DESIGN GP	DRAWN BY LE	DART AEROSPACE LTD HAWKESBURY, ONTARIO, CANADA	
CHECKED GP	APPROVED H	DRAWING NO. DSI 9329	REV. B SHEET 1 OF 1
DATE 06.06.26	TITLE BUBBLE WINDOW INSTALL MOD.		SCALE NTS
A	06.04.25	NEW ISSUE	
B	06.06.26	CHG TO EFFECTIVE AFTER CHG 002

DART SERVICE INSTRUCTION
TO AMEND INSTALLATION INSTRUCTIONS IIN-D044-713 REV. A
REF. CANADIAN STC: SH05-13 ISSUE 1
REF. FAA STC: SR02088NY

FIGURE 1

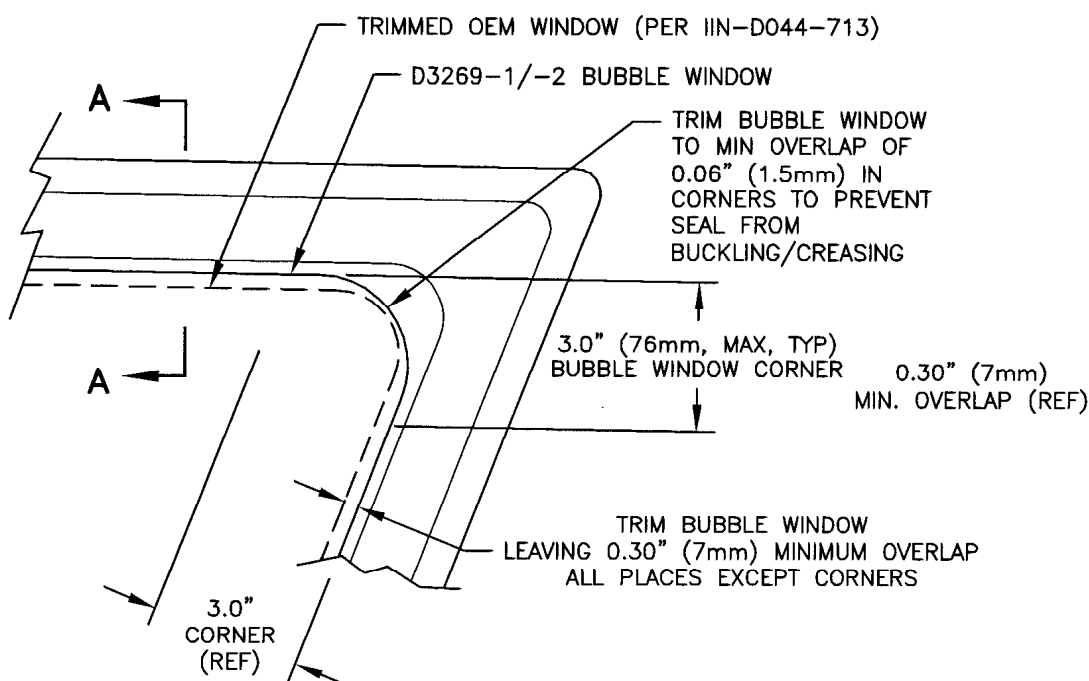
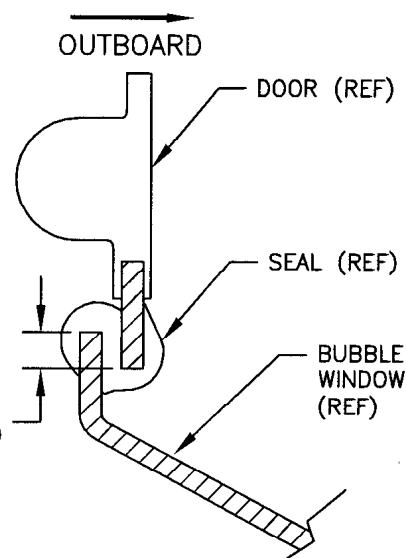
PURPOSE: For the D044-713-013/-014 kits supplied after CHG 002, the D3267-1/-2 bubble windows have been supplied untrimmed to allow for easier installation in the field. The installer must trim the windows in accordance with these instructions prior to installation.

- 1) Modify the R44 crew door per items 3.2.1 and 3.2.2 of Installation Instructions IIN-D044-713 Rev.A.
- 2) Fit and trim the D3269-1/-2 Bubble Window to match the cutout in the door as follows: The bubble window must be a minimum of 0.30" (7mm) larger than the cutout in the OEM window as shown in the figure below. However, in the corners of the window, it is acceptable to trim a 0.06" minimum overlap (1.5mm) to help prevent the D2126-0903 Seal from buckling/creasing in the corners. The edge of the bubble window must be deburred to a smooth finish.
- 3) Continue installing the bubble window per items 3.2.3 through 3.2.5 of the installation instructions.
